Contract #: 04-0120F4Cty: SF/ALA Rte: 80 PM: 13.2/13.9File #: xx.25B**QUALITY ASSURANCE -- NON-CONFORMANCE REPORT****Location:** Changxing Island, Shanghai, China**Report No:** NCR-000925**Prime Contractor:** American Bridge/Fluor Enterprises, a JV**Date:** 27-Nov-2010**Submitting Contractor:** Zhenhua Port Machinery Company, Ltd (ZPMC), Changxing Island**NCR #:** ZPMC-0887**Type of problem:**

Reference Description: Critical Weld Repair on Lift 13W Saddle Grillage without Prior Approval from Engineer

Subject: NCR No. ZPMC-0887

Location: Changxing Island, Shanghai, China**Report No:** NCS-000938**Prime Contractor:** American Bridge/Fluor Enterprises, a JV**Date:** 12-Jan-2011**Submitting Contractor:** Zhenhua Port Machinery Company, Ltd (ZPMC), Changxing Island **NCR #:** ZPMC-0887**Type of problem:**

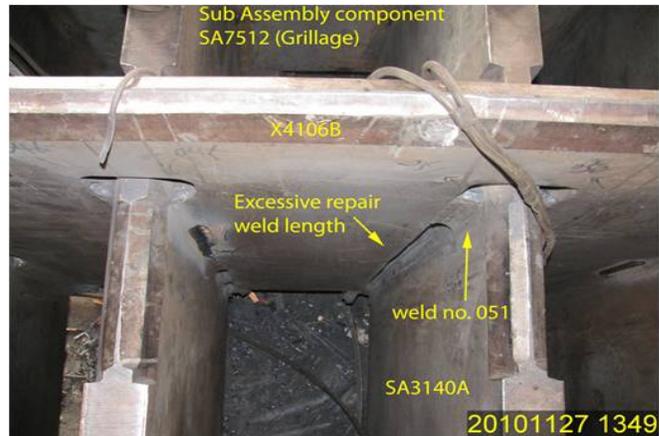
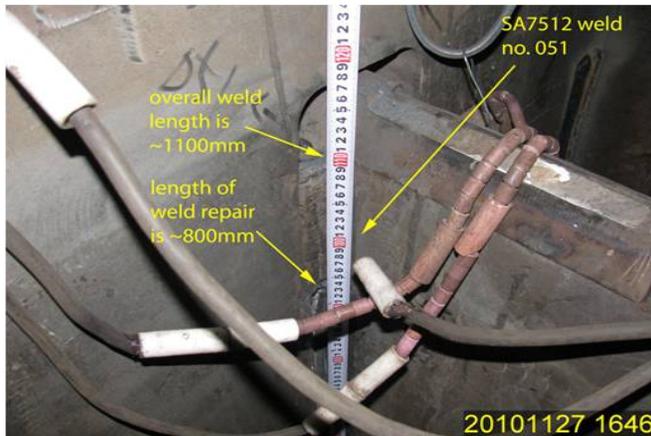
- ZPMC has performed Critical Weld Repairs (CWR) on Seismic Performance Critical Material (SPCM) without the Engineers approval.
 - The length of the excavation exceeded the limits of a Non Critical Weld Repair as defined in Section 12 of AWS D1.5 2002.
 - The length of excavation as measured by this QA was approximately 800mm on a 1100mm long weld.
 - The weld is identified as SA7512-051.
 - The repair documentation available for review was identified as B-WR-17780 and WPS-345-FCAW-3G (3F)-FCM-Repair.
 - The weld is a Complete Joint Penetration (CJP) joint, joining component identified as SA3141A to component identified as X4106B. Both plates are identified as SPCM on the approved shop drawings.
 - OBG Sub Assembly SA7512A is located in Bay 2.
- For further information, please see the attached pictures below.

AWS D1.5M – 2002 section 12.17.2(4) Noncritical Repair Welds – “First time excavation and repair from one side of groove welds and fillet welds which contain unacceptable porosity, slag, and fusion discontinuities, provided the excavations do not exceed the following limits: Length of weld “L” over 1.0m to 2.0m excavation is not to exceed 450mm.”

AWS D1.5M – 2002 section 12.17.3 Critical weld repairs. “Except as provided in 12.17.2, all welded repairs shall be considered critical. They include, but are not limited to the following:

(5) Corrections requiring weld removal and re-welding except as provided in 12.17.2 (4)”.

Reference Description: Critical Weld Repair on Lift 13W Saddle Grillage without Prior Approval from Engineer

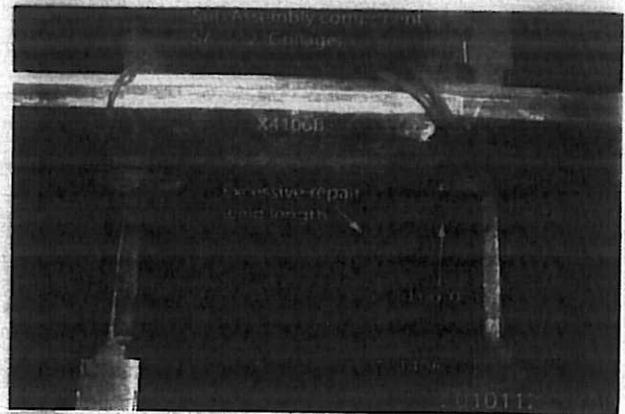
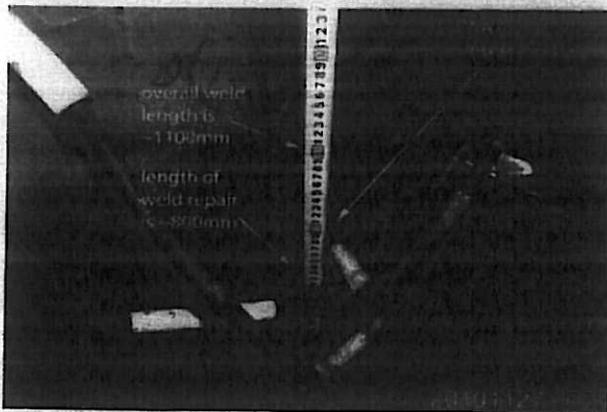
- ZPMC has performed Critical Weld Repairs (CWR) on Seismic Performance Critical Material (SPCM) without the Engineers approval.
 - The length of the excavation exceeded the limits of a Non Critical Weld Repair as defined in Section 12 of AWS D1.5 2002.
 - The length of excavation as measured by this QA was approximately 800mm on a 1100mm long weld.
 - The weld is identified as SA7512-051.
 - The repair documentation available for review was identified as ~~17609~~ / 17609 RS Acc. B-WR-17780 and WPS-345-FCAW-3G (3F)-FCM-Repair.
 - The weld is a Complete Joint Penetration (CJP) joint, joining component identified as SA3141A to component identified as X4106B. Both plates are identified as SPCM on the approved shop drawings.
 - OBG Sub Assembly SA7512A is located in Bay 2.
- For further information, please see the attached pictures below.

AWS D1.5M – 2002 section 12.17.2(4) Noncritical Repair Welds – “First time excavation and repair from one side of groove welds and fillet welds which contain unacceptable porosity, slag, and fusion discontinuities, provided the excavations do not exceed the following limits: Length of weld “L” over 1.0m to 2.0m excavation is not to exceed 450mm.”

AWS D1.5M – 2002 section 12.17.3 Critical weld repairs. “Except as provided in 12.17.2, all welded repairs shall be considered critical. They include, but are not limited to the following:

(5) Corrections requiring weld removal and re-welding except as provided in 12.17.2 (4)”.

Contractor will provide the NDT report to prove the weld repair is acceptable. ZPMC will issue an internal NCR and will remind the site personnel the necessity to notify and seek approval from Engineer when the length of excavation on weld exceeds the limits of Non Critical weld repair as defined in AWS D1.5 , Section 12.

Contractor provided the NDT report proving the weld repair was completed satisfactorily. Internal NCR issued to the QC personnel involved. QA from Contractor also discussed with the site personnel reinforcing that Engineer must be notified when the length of excavation on weld exceeds the limit of Non critical weld repair defined in Code.
